PBK, P.O. BOX 880, GRIFFIN, GA 30223

ADDENDUM NUMBER THREE: DATED: October 08, 2026

This addendum forms a part of the Contract Documents and modifies the original Specifications and Drawings dated September 11, 2026, as noted below. **Acknowledge receipt of this Addendum in the space provided on the Bid Form;** failure to do so may subject bidder to disqualification.

Whitewater High School
Renovations

M-101K

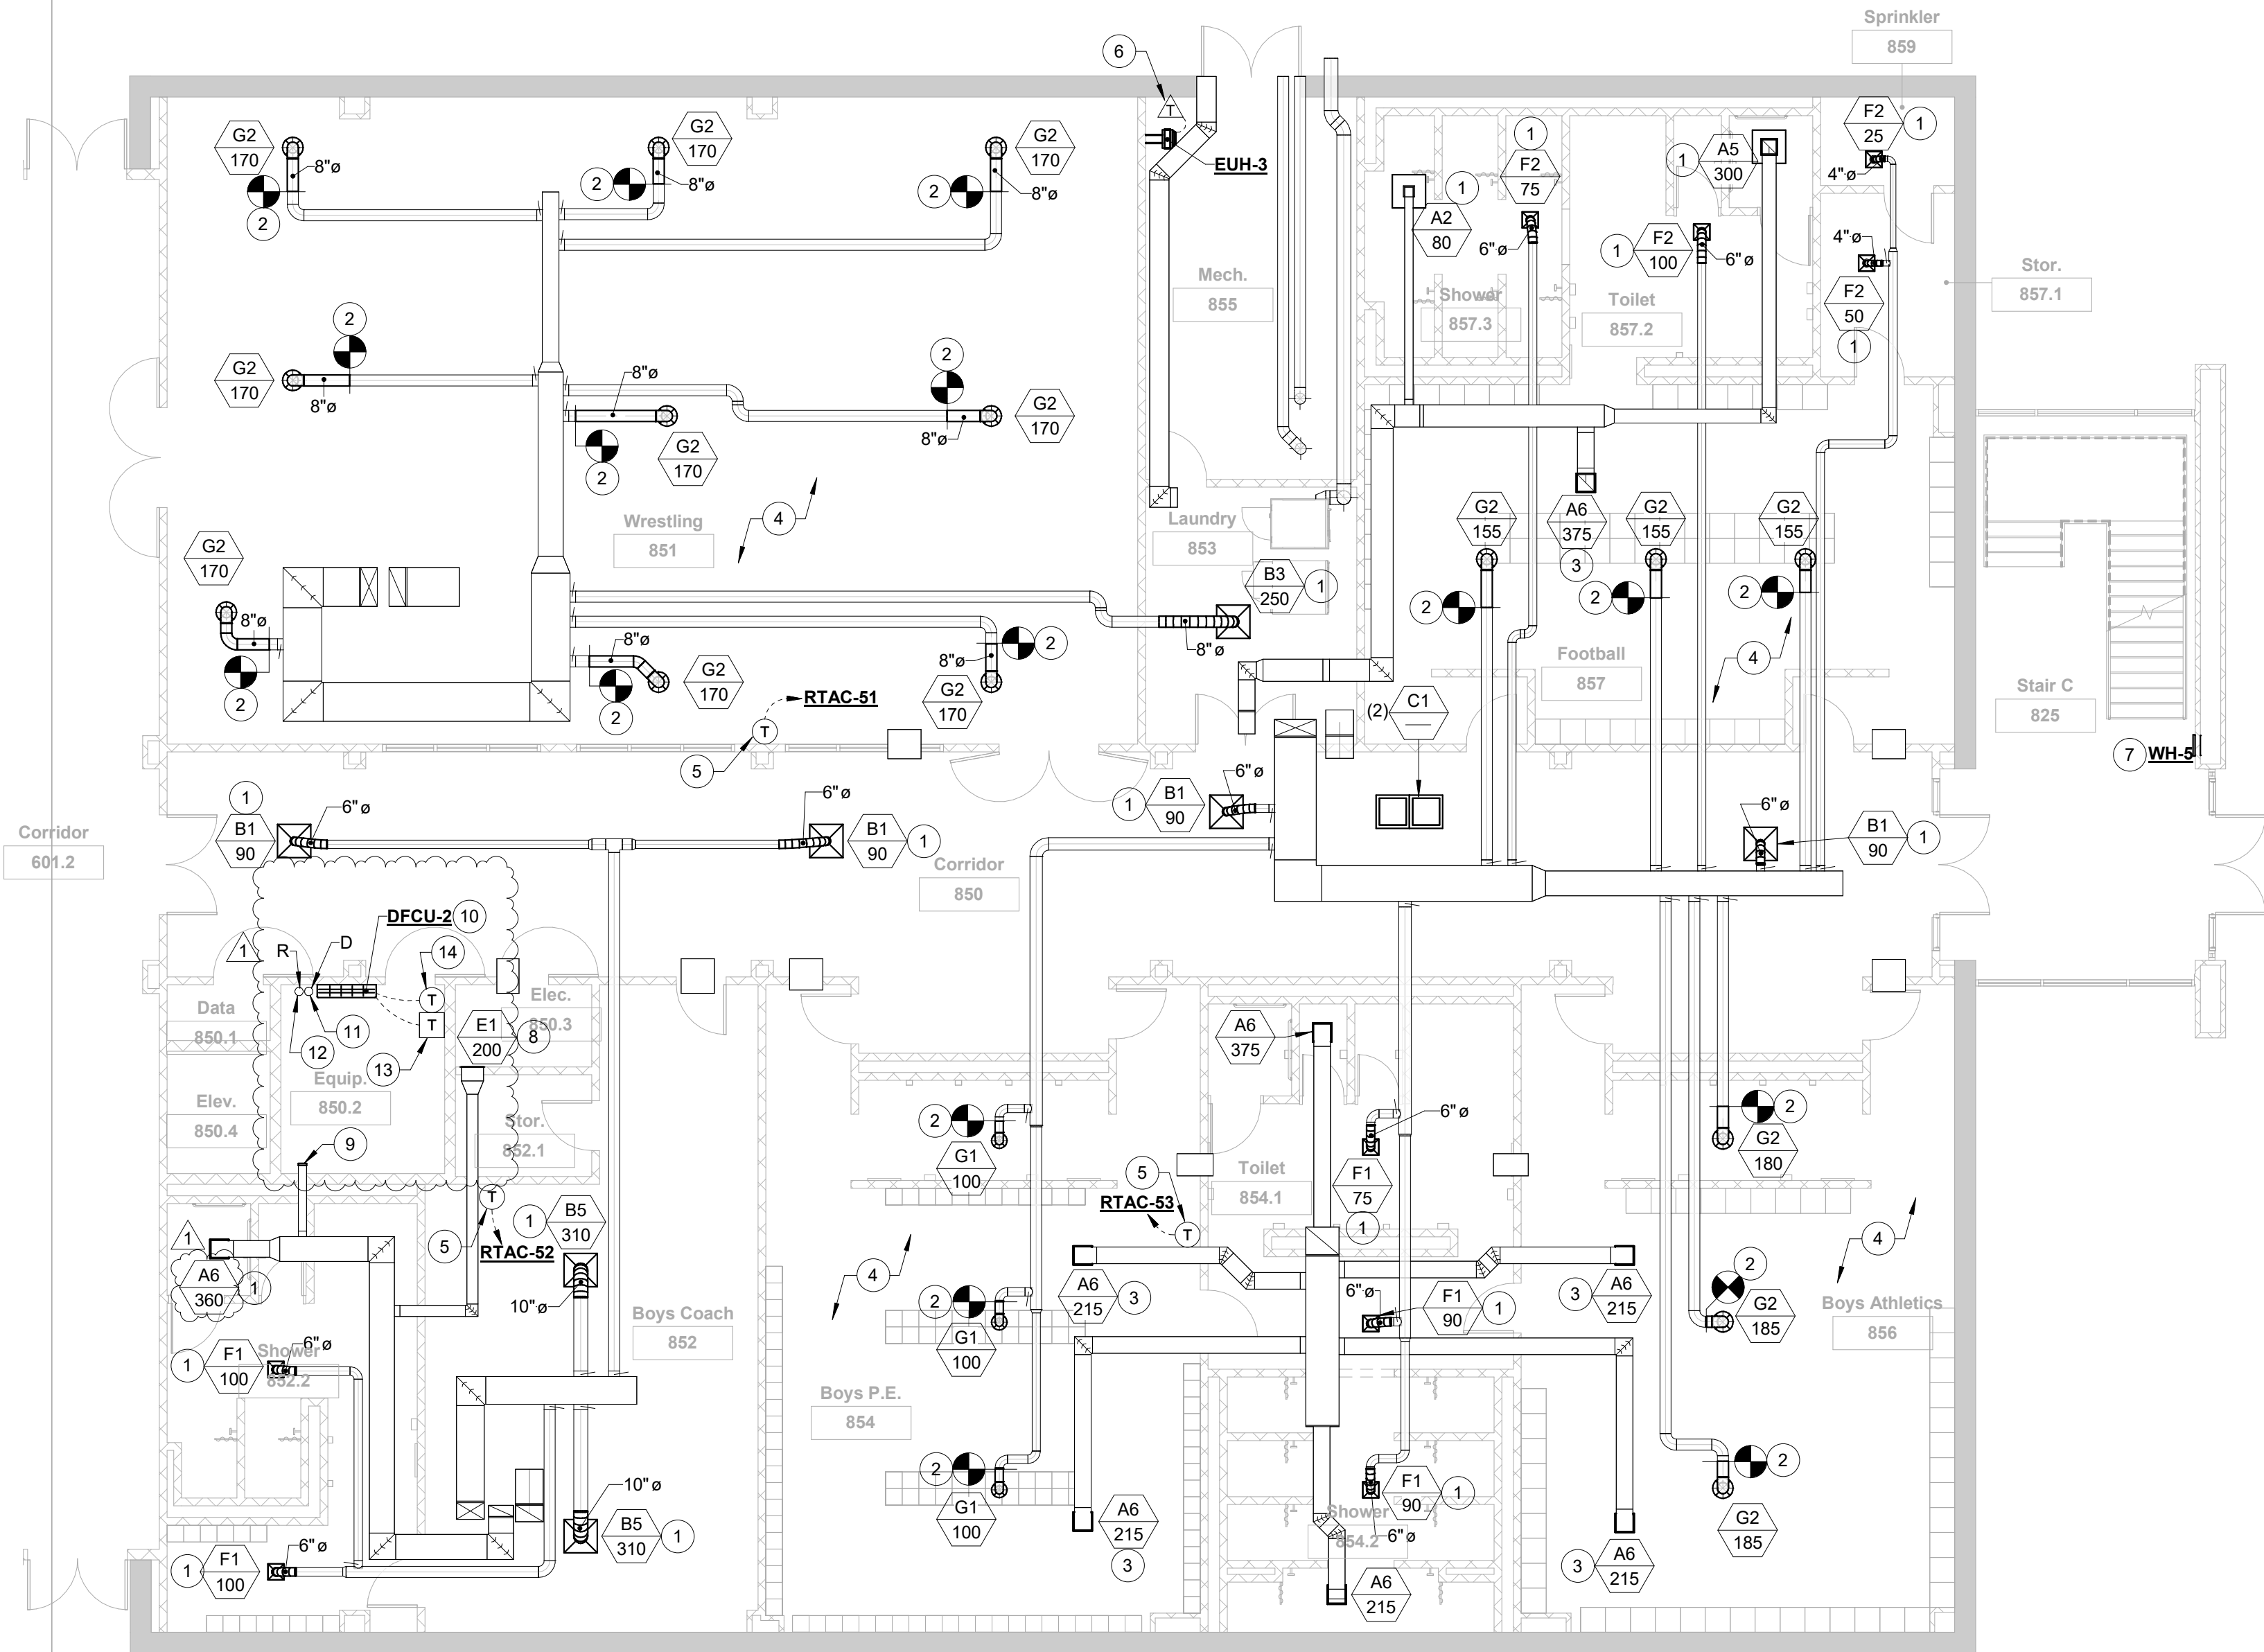
3. SHEET M-101K - MECHANICAL LEVEL 1 - AREA K FLOOR PLAN
 - A. Delete Sheet M-101K in its entirety and replace with Sheet M-101K included in this addendum.
